The Director  
Key Sites Assessments, Planning and Assessment  
Department of Planning, Industry and Environment  
Locked Bag 5022  
PARRAMATTA NSW 2124

**Harbourside Shopping Centre Redevelopment (SSDA7874)**

*Current proposal*

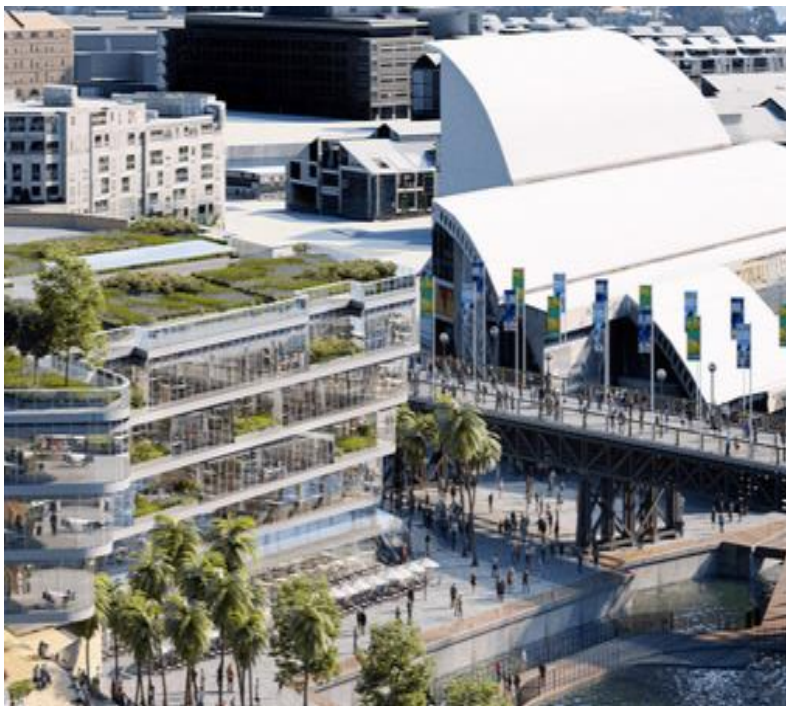
My submission is that I **object** to the bulk and scale of the northern portion of the podium due to:

- its visual impact on Pyrmont Bridge and Darling Harbour more broadly;
- it will not allow the full span of the bridge to be viewed from significant parts of the harbour;
- its inconsistent scale and proportions of the tower (as amended);
- it dominates the foreshore; and
- it still significantly inhibits the views of half the floors of 50 Murray Street (up to level 8).

The Department should give consideration to **amending the envelope for the northern portion of the podium consistent with the Cockle Bay Wharf approval (SSD 7684)** to RL12 for that portion of the podium facing the harbour and abutting Pyrmont Bridge and then rising to RL19. These RL's should be maintained for 75 metres to the south and then rising to RL26.

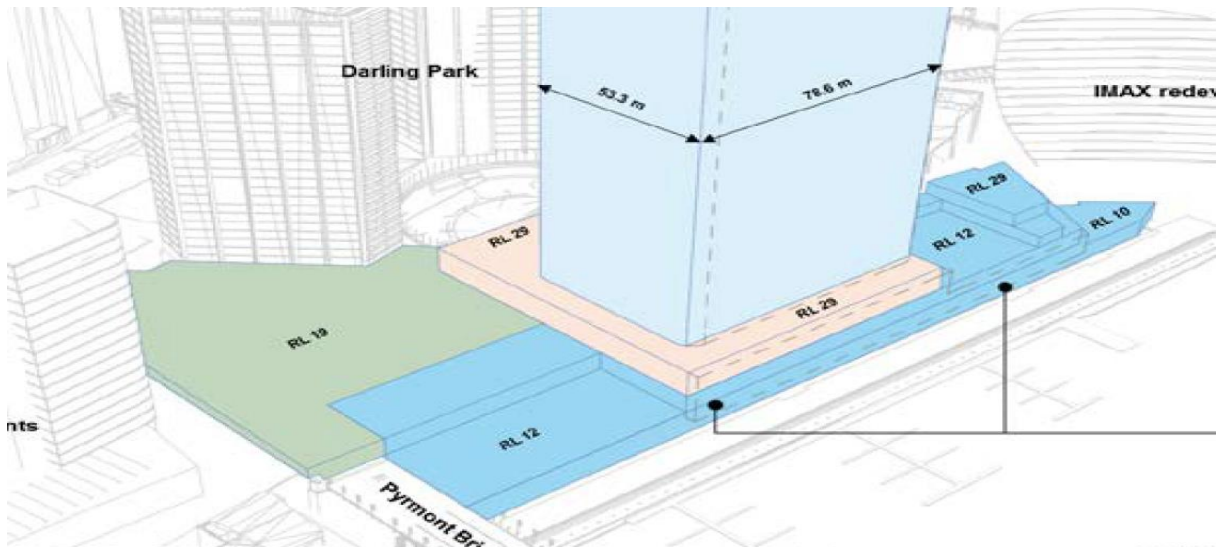
The issue of bulk and scale was by and far the dominant issue raised in past objections.

The Applicants (both Planner and Architect) have made little attempt to address the 'bulk and scale' issue and have increased the footprint in some parts of the project to ensure they maintain their 87,000sqm GFA. I note use of the word - 'minor' - was a good description for the effort to address such a significant issue.
